Proposal for an amendment to Regulation No. 78 (Uniform provisions concerning the approval of vehicles of categories L₁, L₂, L₃, L₄ and L₅ with regard to braking)

Submitted by the expert from International Motorcycles Manufacturers Association

The text reproduced below was prepared by the expert from IMMA in order to introduce amendments to clarify the text and introduce simplified test procedures in this regulation and align it with gtr 3. The modifications to the current text of the Regulation are marked in bold or strikethrough characters.

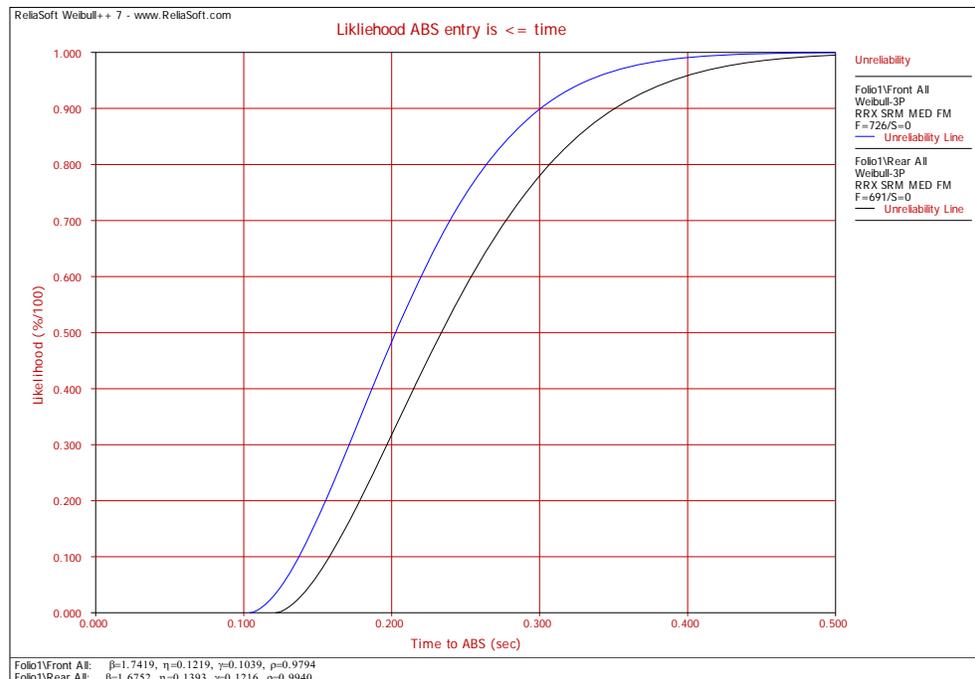
- 8) This amendment aligns R78 and GTR 3 with respect to the simple test method and also updates the use of SI units and change in decimal points.
- 9) It has been noticed in testing that the brake application rate specified in section 4.9.5.1 can result in a large number of test failures. It can be seen in the chart below that the 0.2 second lower limit shows a failure rate is between 30% and 50% of the time.

By reducing the lower limit to 0.1 seconds the test failure rate reduces to practically zero. Allowing the reduction tends to make the regulation more stringent by including a greater number of brake force application rates and eliminates restrictive test requirements.

The brake control actuation force is applied in **0.1 – 0.5** secs.
